West Rankin Utility Authority | Administration Building
WBA Project No. 5719

ADDENDUM NO. 02

1 FIRST FLOOR PLAN
1/8" = 1'-0"

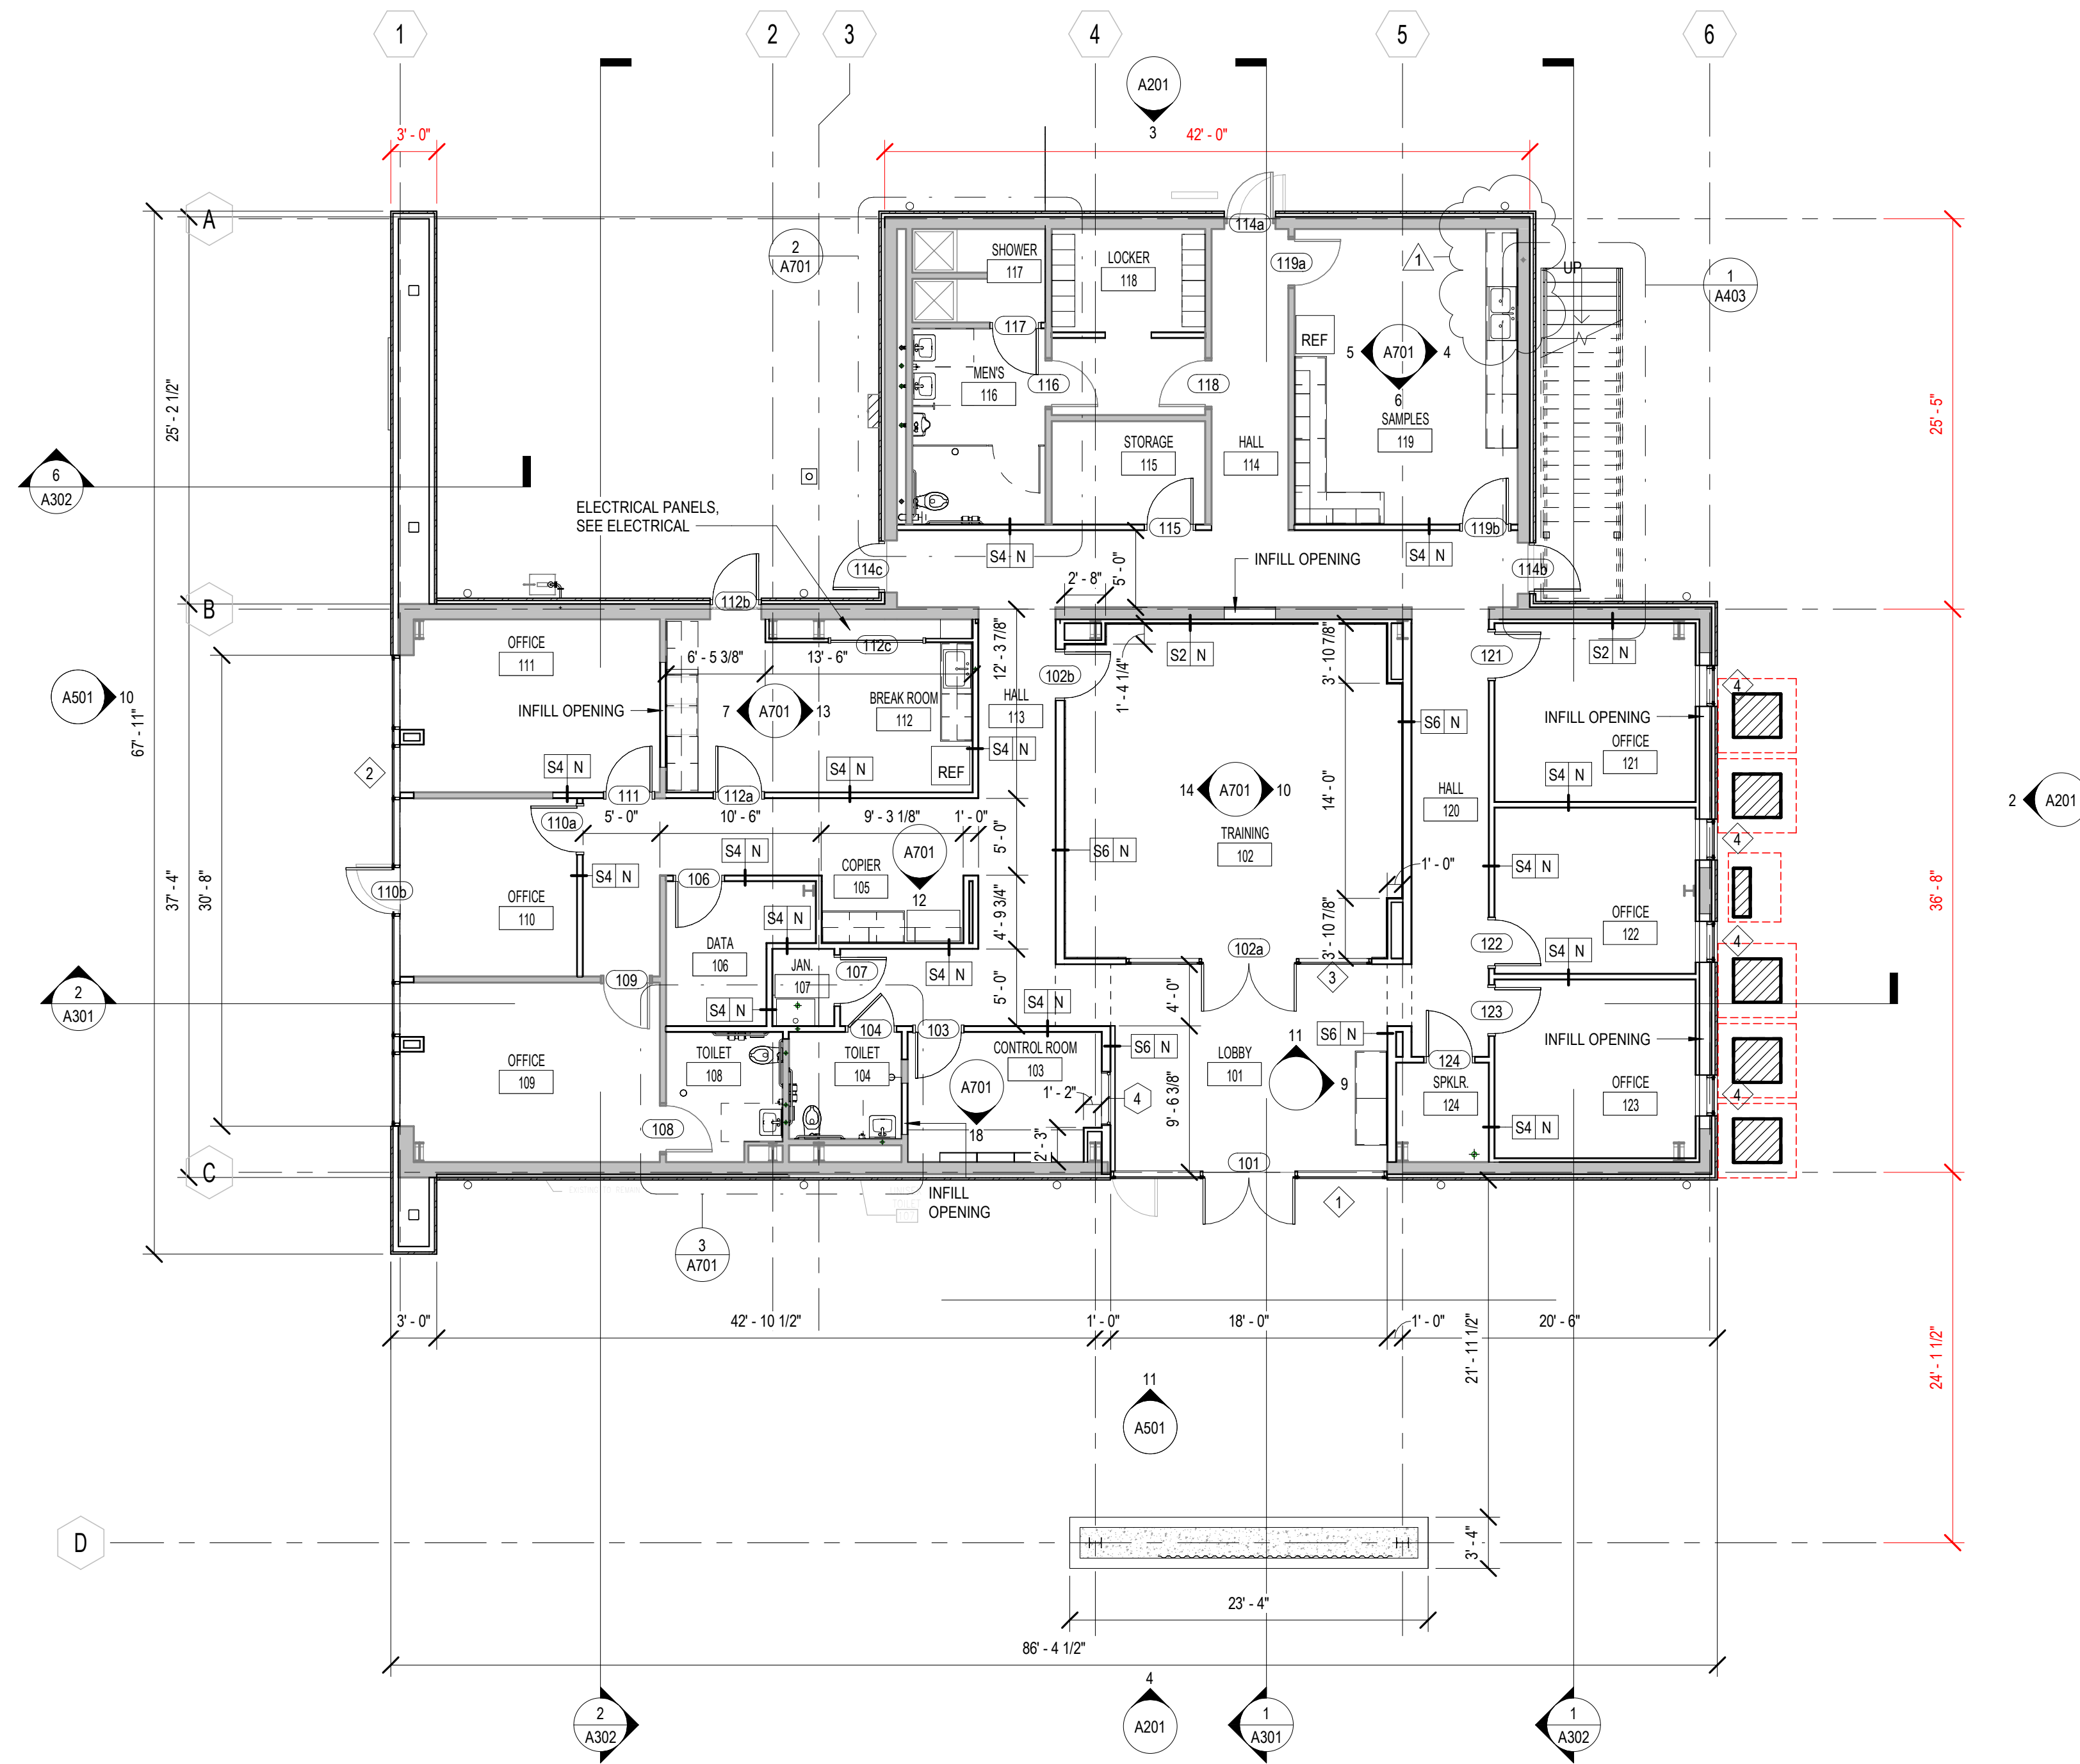
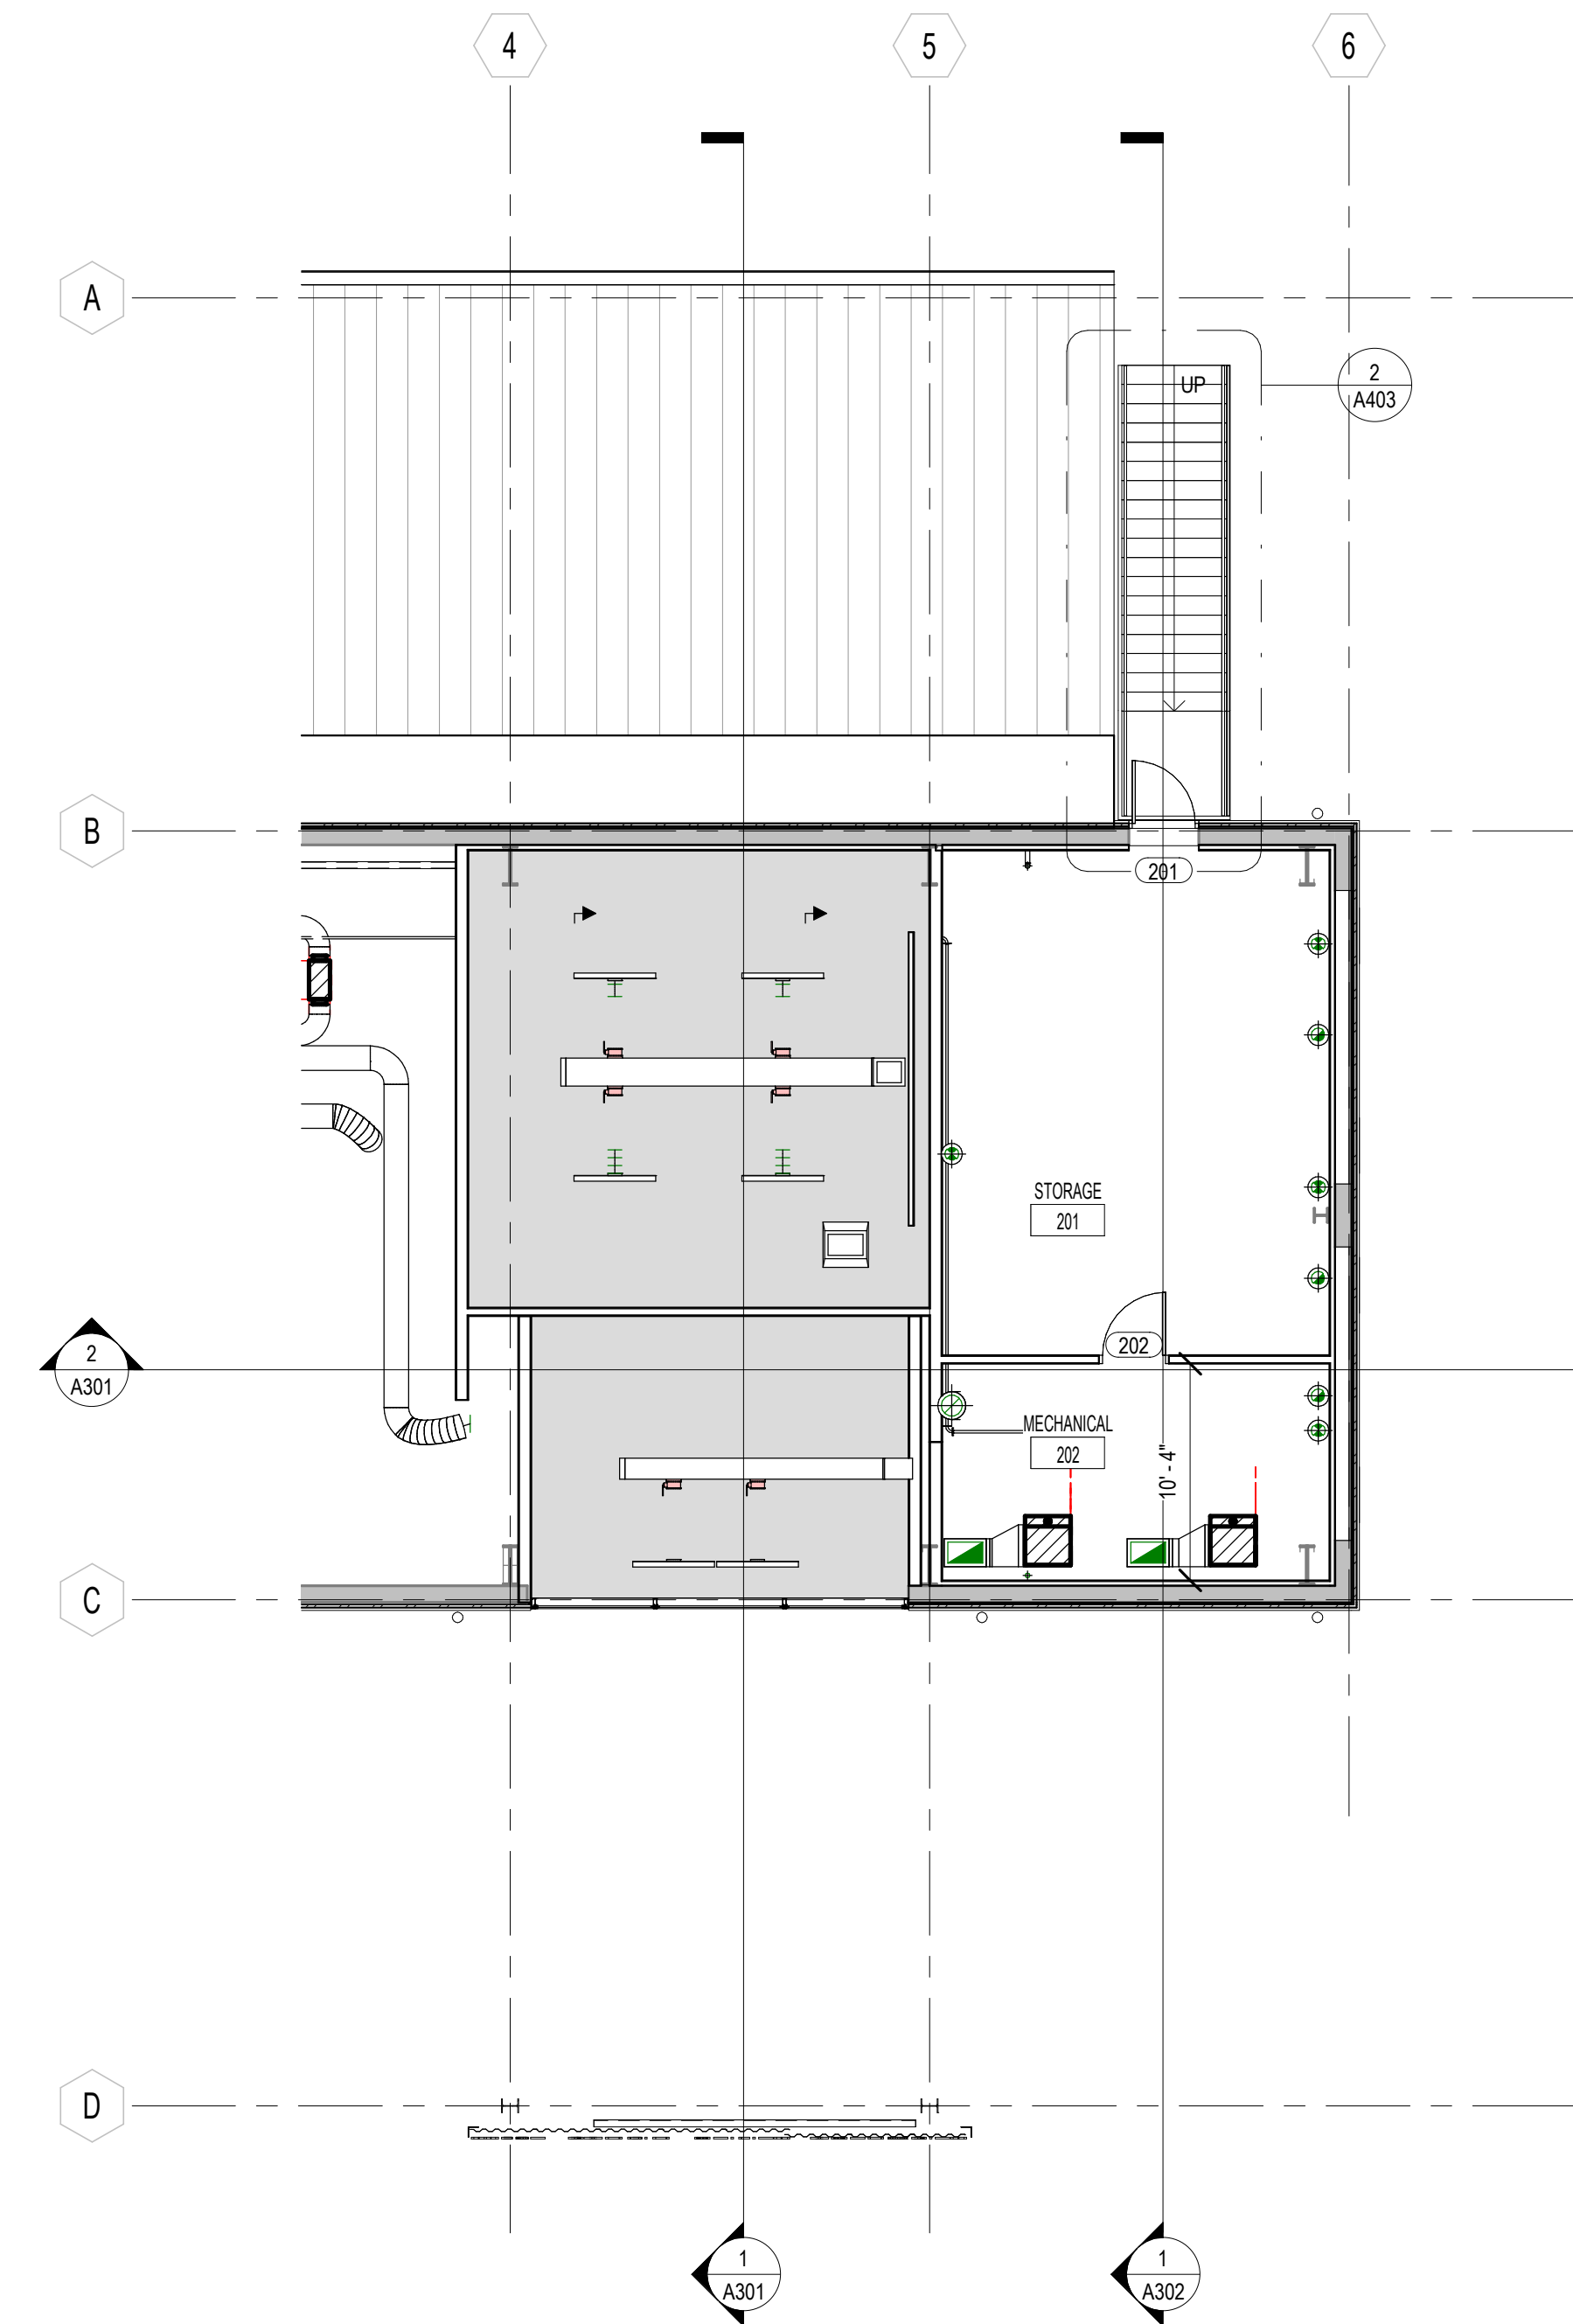
- ITEM NO. 3** **SHEET C201 Site Plan**
ADD indication for extent of asphalt paving.
- ITEM NO. 4** **SHEET C302 Storm Drainage Layout**
DELETE 8'-0" section of storm drainage pipe.
- ITEM NO. 5** **SHEET D100 Demolition Plan**
ADD Demolition Keynote 16 – Remove split-faced concrete block at exterior of lower level office.
ADD Demolition Keynote 17 – Remove roof overhang at north end of lower level as required for new construction. Maintain weather tightness at exposed edge.
- ITEM NO. 6** **SHEET A501 Doors and Windows**
ADD note to DOOR SCHEDULE: Access control will be keypads and devices provided per door hardware allowance. All installation provisions to be provided in base bid.
- ITEM NO. 7** **SHEET A501 Floor Plans**
REVISE sink location in SAMPLES 119

HVAC New Work Plan
1/4" = 1'-0"

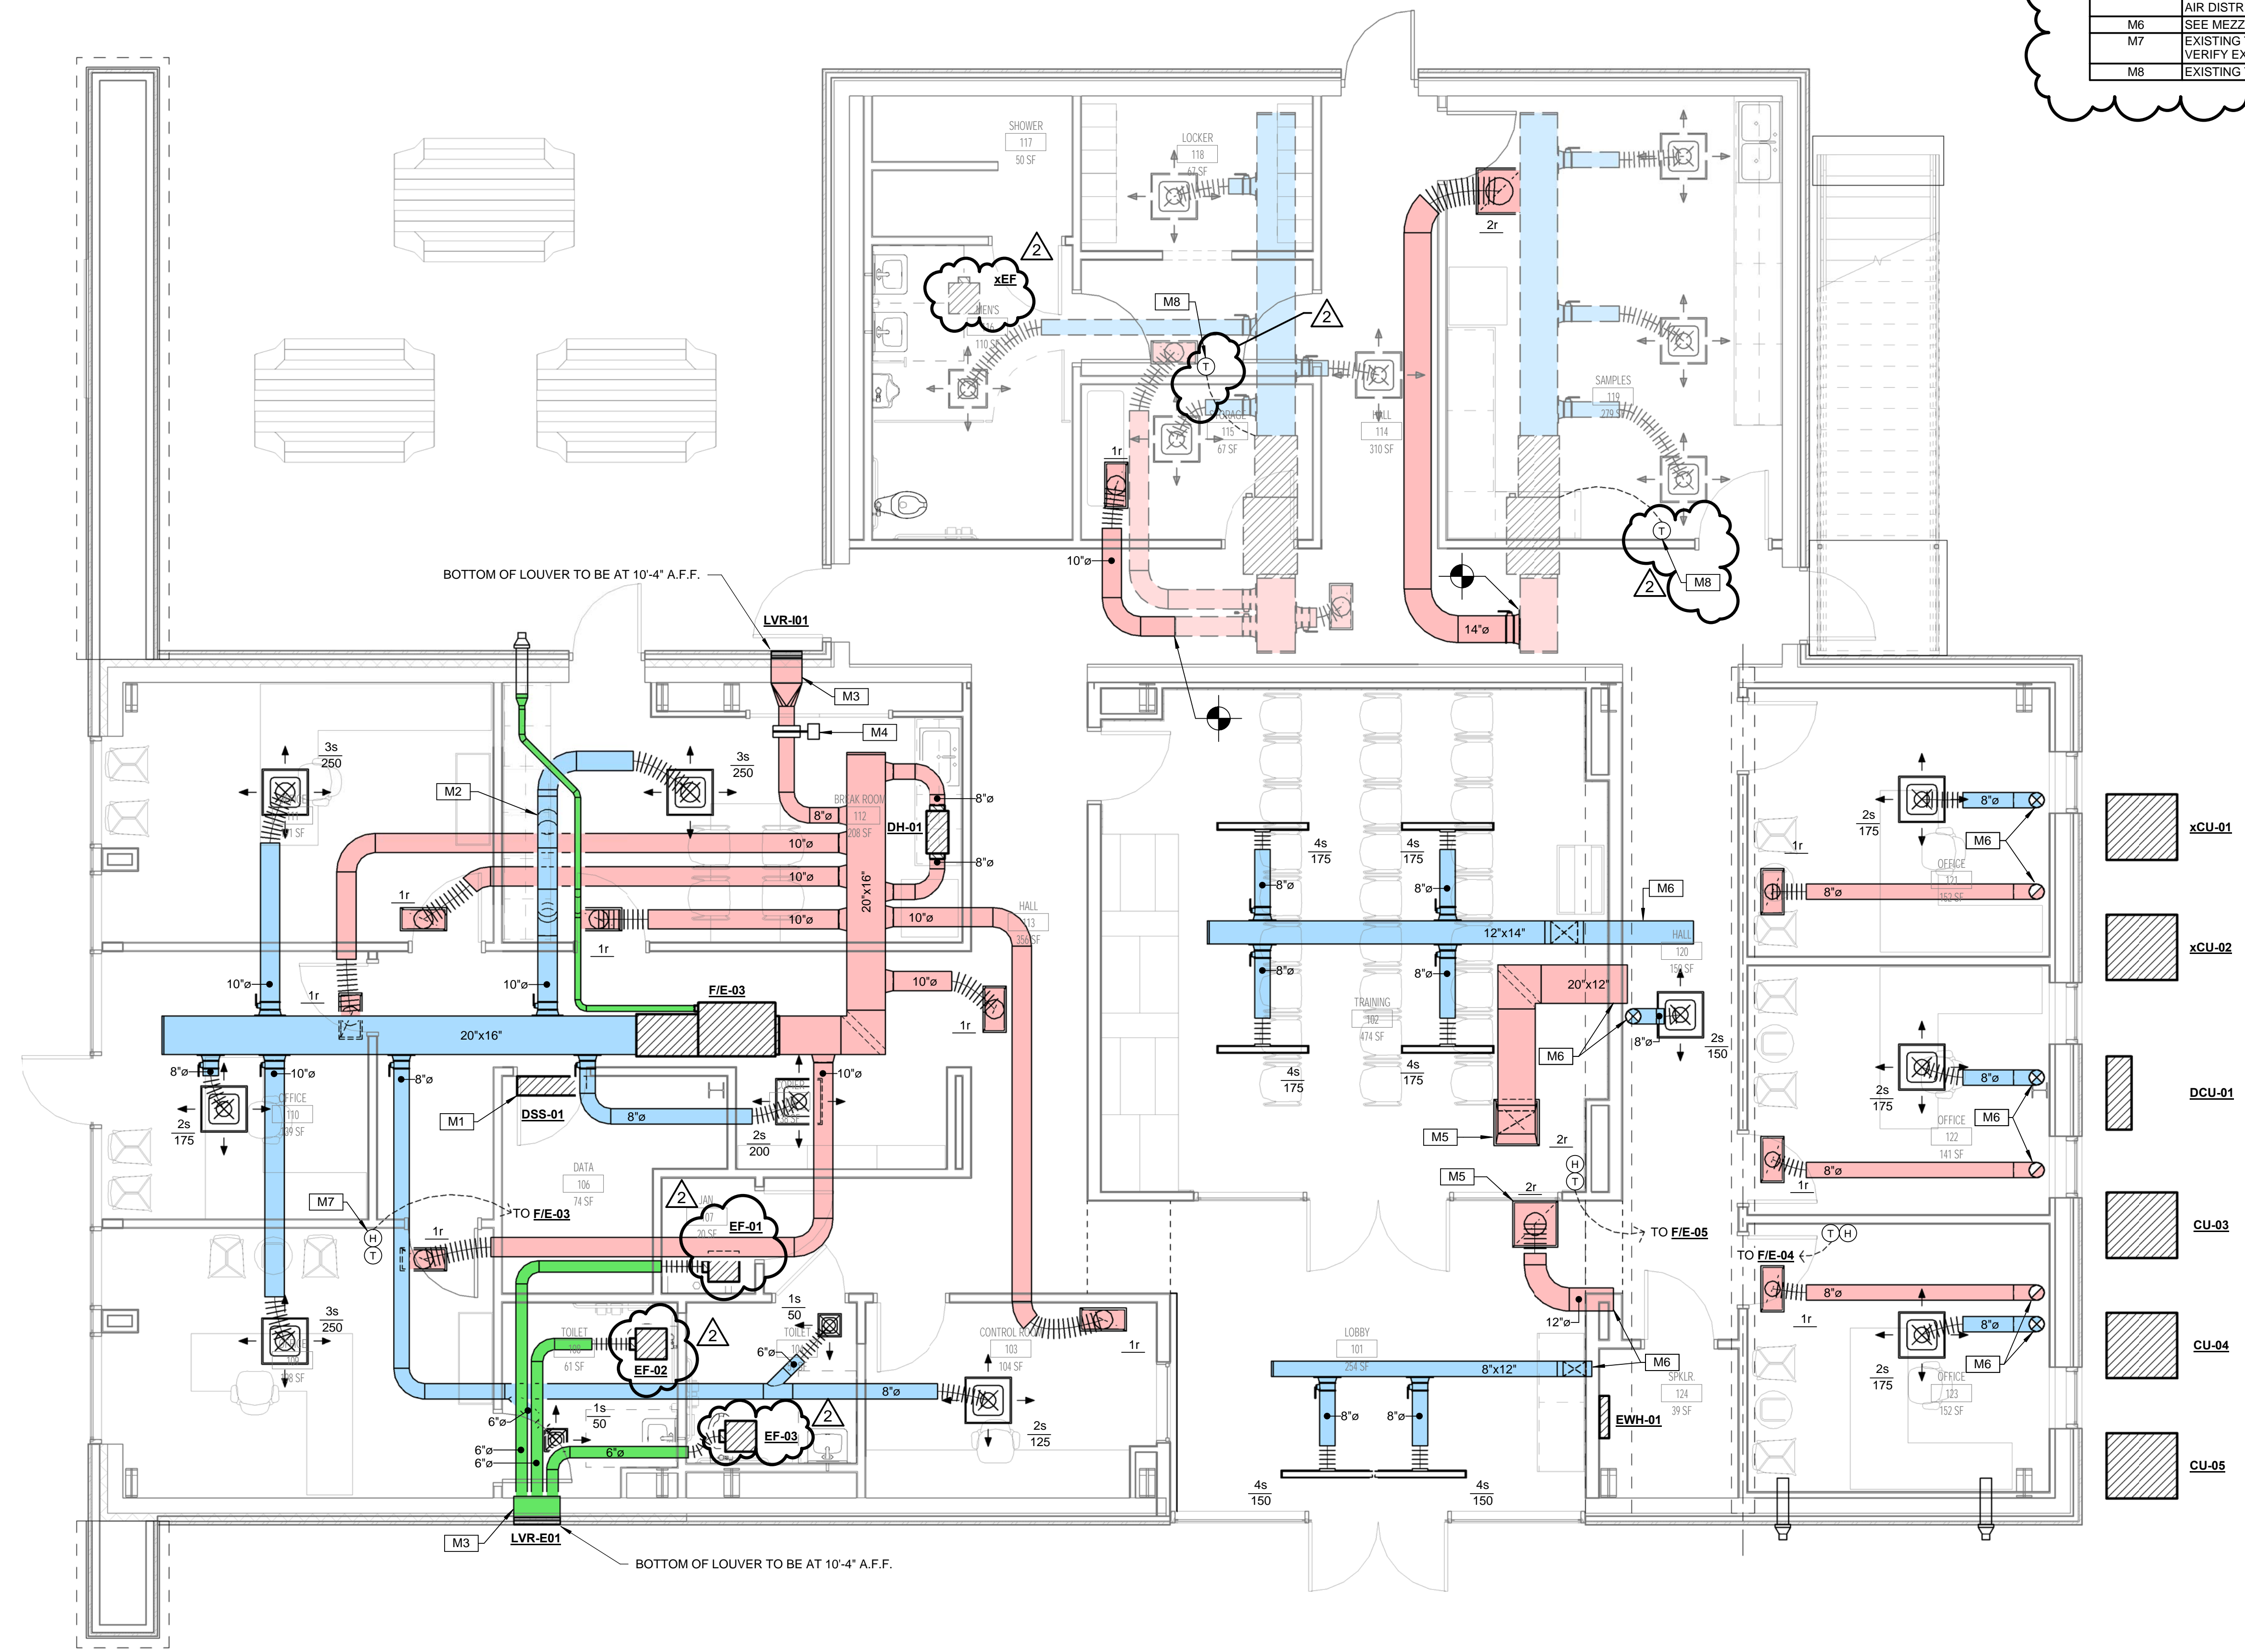
- ITEM NO. 8** **SHEET A701 Interior Elevations**
REVISE sink location in SAMPLES 119
DELETE under cabinet lighting in Break Room 112
- ITEM No. 9** **SHEET M101 HVAC New Work Plan**
DELETE sheet in its entirety and **REPLACE** with attached sheet. Revised to add specific notes in the upper right-hand corner. Revised Exhaust Fan labeling to match Fan Schedule. Revised to remove humidistat in Rooms "SAMPLES 119" AND "HALL 114".
- ITEM NO. 10** **SHEET E001 Panel Schedule**
ADD Circuit for WH-01 to Panel MA
- ITEM NO. 11** **SHEET E301 Mechanical Plan**
ADD Circuit for WH-01
